All of the modifications listed in this appendix will be incorporated into the product when manufactured and placed on the market, as per the requirements of Section 10.2.13 of ANSI C63.4.

Table 3.2-1: EUT Modifications

Figure A3: fair-rite Part # 0431167281 (1 pass) on AC power cord outside enclosure

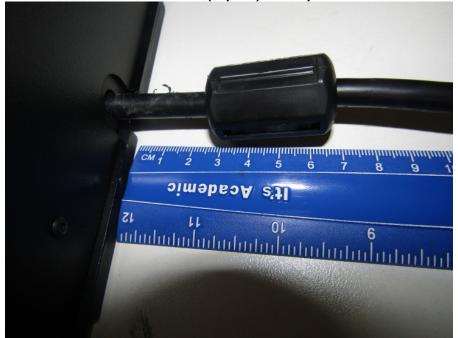
| ☐ Modifications were not required to bring the EUT into compliance with the requirements. ☐ Modifications were required to bring the EUT into compliance with the requirements. | | | | | |
|--------------------------------------------------------------------------------------------------------------------------------------------------------------------------------------------------------------|----------------------------------------------|---------------------------|-------------------------|------------------|---------------------------|
| Ferrites | Fair-rite part # 0431167281 (1 pass) | AC power cord, externally | Radiated Emissions | 30MHz- 40MHz | Photo Number: A1, A3 |
